Your feedback on Hendry Avenue, Hillsborough – Safety Improvements

We proposed upgrades to Hendry Avenue to improve the South Western Cycleway link and make the road safer for everyone. The consultation from the 28 November 2022 to the 16 December 2022 and received a total of 61 submissions. We had one feedback submission through a phone call to Auckland Transport's Customer Focus Team and a total of 60 online submissions. Seven of those online submissions were blank and removed from the data set, resulting in an overall 54 submissions on the consultation.

What are we seeking feedback on?

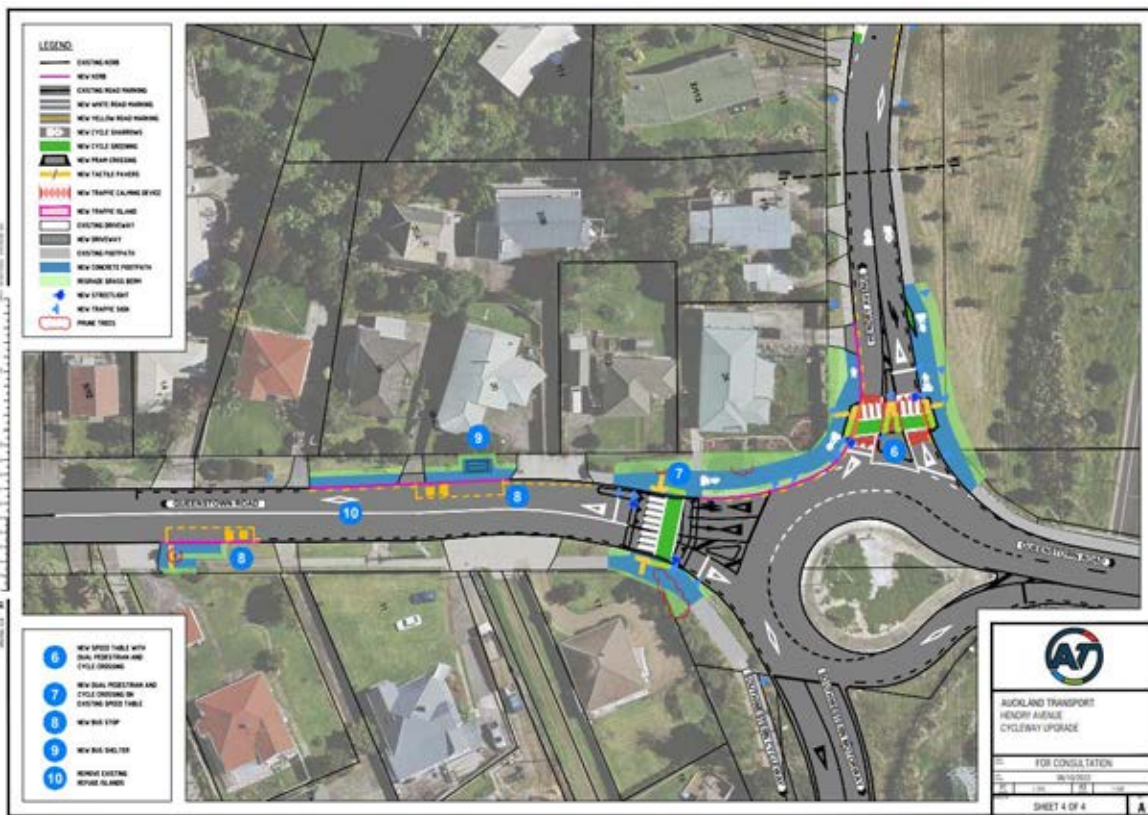
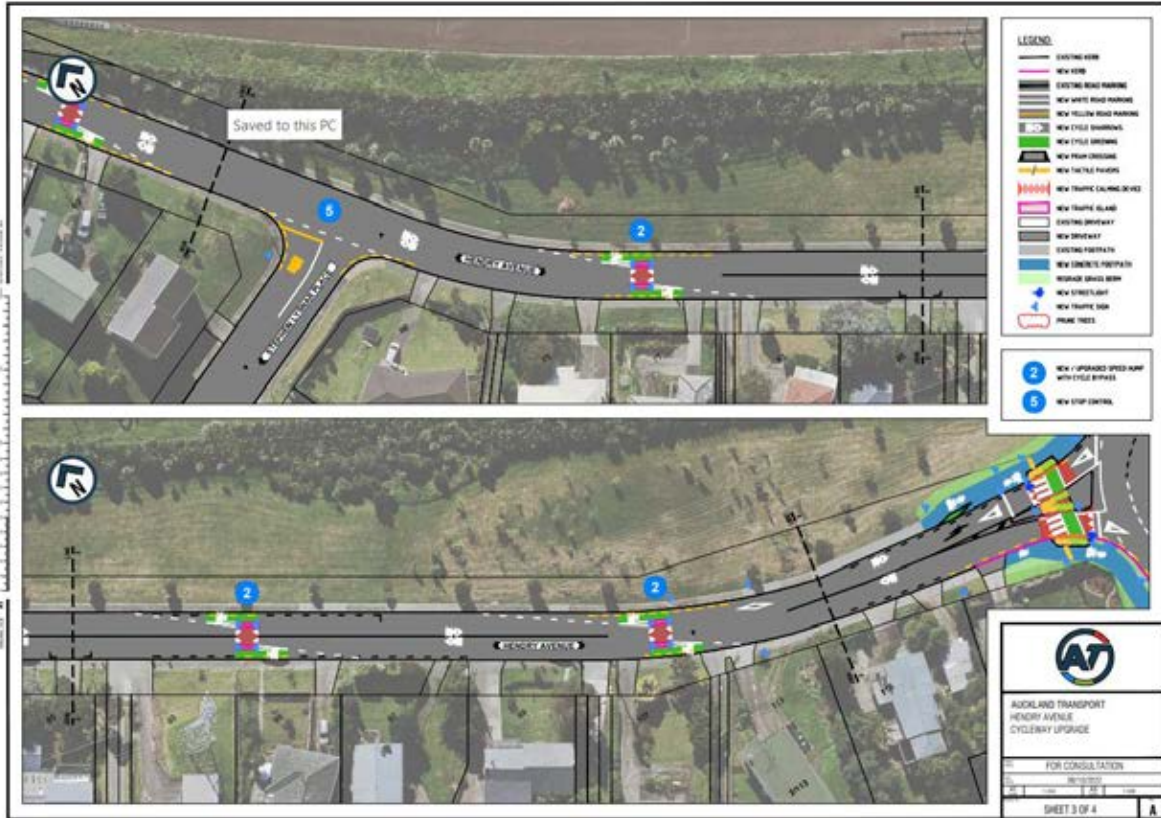
Feedback	AT Response
BUS STOP	
Concern that installing new bus stops 180m from the existing bus stops on an underutilised bus service defies any cost/benefit analysis.	The existing bus stop is part of a different bus route. The bus stop we're proposing would reduce the walking distance for bus users from approximately 500m to 250m.
Concern about the bus stop location at 20 Queenstown Road as the area is congested already. Suggestion to put the bus stop outside 12 or 14 Queenstown Road to allow traffic to pass a stopping bus freely.	The proposed bus stop would be used by buses for approximately 30 seconds to quickly drop off/pick up passengers and should have a very minor impact on any traffic congestion.
Concern that the current patronage of 68 bus on this part of the route is currently negligible.	The bus stop you are referring to is part of a different bus route. We try to ensure that bus stops are within 200-300 metres of each other as this is a comfortable distance for most people. The bus stop we are proposing will reduce the walking distance for bus users from approximately 500m to 250m.

SPEEDING AND SPEED BUMPS	
Concern about the placement of the speed bump outside 95 Hendry Avenue as it's at the top of the hill with low visibility for traffic coming into a single lane.	We'll do a safety assessment of our design and will make necessary changes after the review.
Concern that the number of speed bumps is excessive.	The number of speed bumps has been determined based on what would be most effective at encouraging slow, safe speeds of 30km/h. If there were fewer speed bumps, drivers may travel faster than 30km/h between speed bumps.

LOCATION OF PROPOSAL	
<p>Concern that proposed raised crossing on Hendry Avenue near the roundabout is too close to Queenstown Road. Suggestion to move proposed raised crossing at further into Hendry Avenue.</p>	<p>The crossing on Hendry Avenue and Queenstown Road was designed with pedestrian and cyclist safety in mind. We're unable to move the crossing further down Hendry Avenue because it would make it difficult</p>

Concern that putting a cycle way on a blind corner is dangerous, as vehicles are travelling at high speed around that corner and cars cross the inferred centreline due to parked vehicles and road width.	Our proposal ensures a safer corner because of the raised section of road (which functions like a speed bump) and painted broken yellow lines (no stopping at all times) which will prevent parked vehicles from blocking visibility. Drivers will be able to see cyclists sooner and approach the corner at slower speeds.
Suggestion to install mirrors to see traffic coming from 10 and 15 Hendry Avenue as they are blind corners with a lot of traffic at peak hours.	Mirrors can sometimes increase risk because it can be difficult for inexperienced road users to use them safely. Our proposal includes a raised corner which will encourage lower speeds and make it easier for drivers to see each other.
Concern about the sharp increase in non-resident traffic using Hendry Avenue as a shortcut to Hillsborough Road.	The changes will reduce the overall speed on Hendry Avenue which should deter non-resident traffic using Hendry Avenue as a shortcut.
